TITLE:- 3LEAF RIGHT SIDE CRM DOOR 03				NIHVA TECHNOLOGIES PVT. LTD. PUNE Tel : 020 66304033 Email:- info@nihva.com Website:- www.nihva.com
	NAME	DATE	SIGN	
DRAWN	SUJATA	26/04/2022		CLIENT - LESTECH
CHECK	M.SUTAR	26/04/2022		LOCATION - POSCO MANGAON
APPRD.	V.TARAK	26/04/2022		PRODUCT - SLIDING DOOR
If any queries contact : design@nihva.com				DWG NO:-NIHVA/22-23/CLT/0015 REV- 0
ALL DIMENSION ARE IN mm				SCALE: NTS SCALE:-- 1:1 SHEET: 01 OF 01

Deatil A

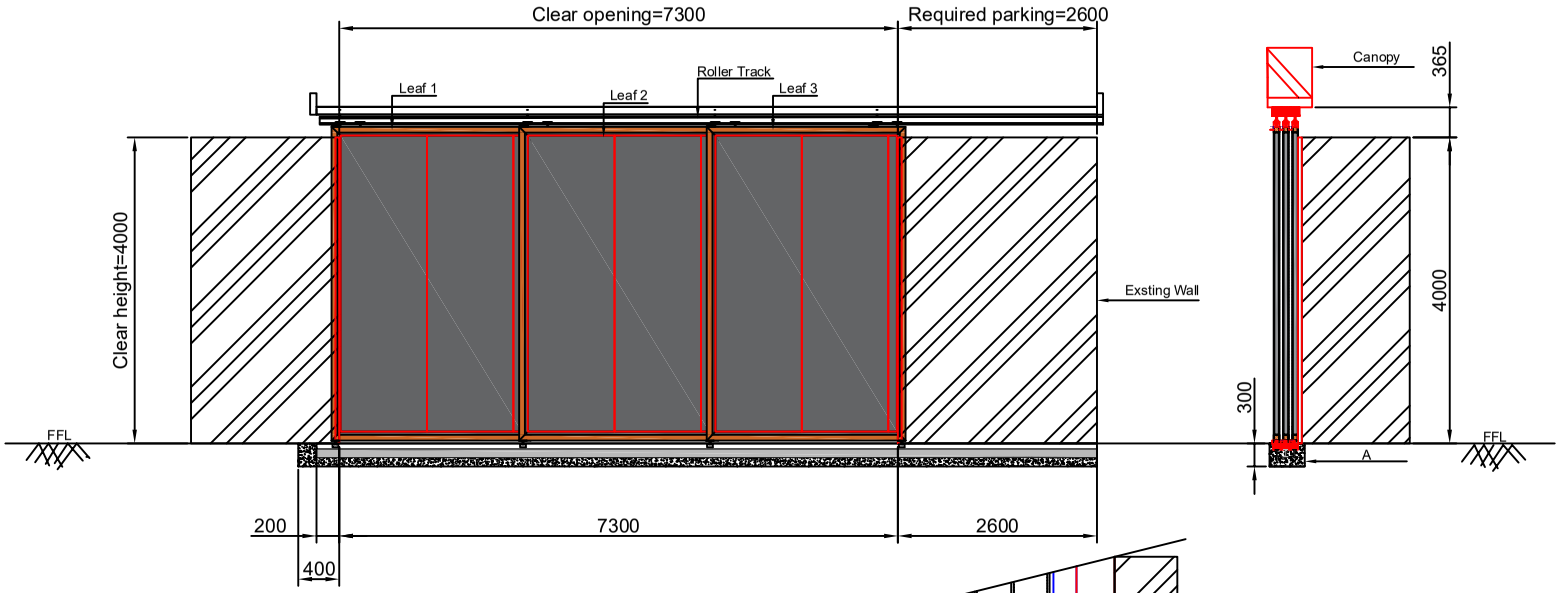
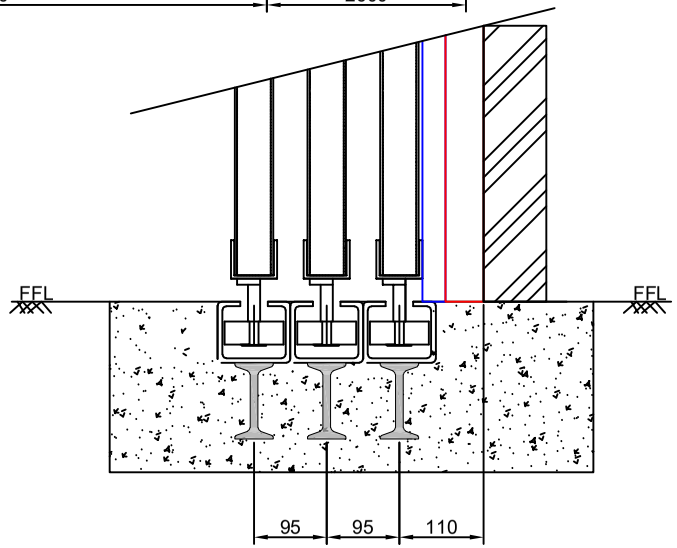
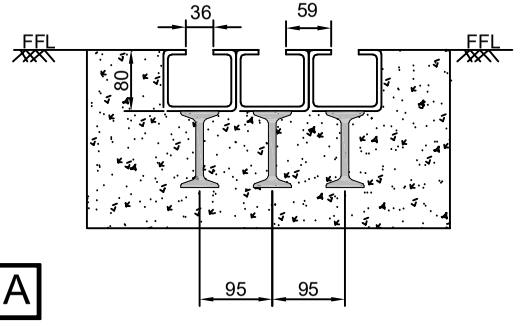
Client scope
* Drainage area or pipe need to be shift from right side *Roof need to be shift at top Approx 300mm *Gutter need to be close till pipe
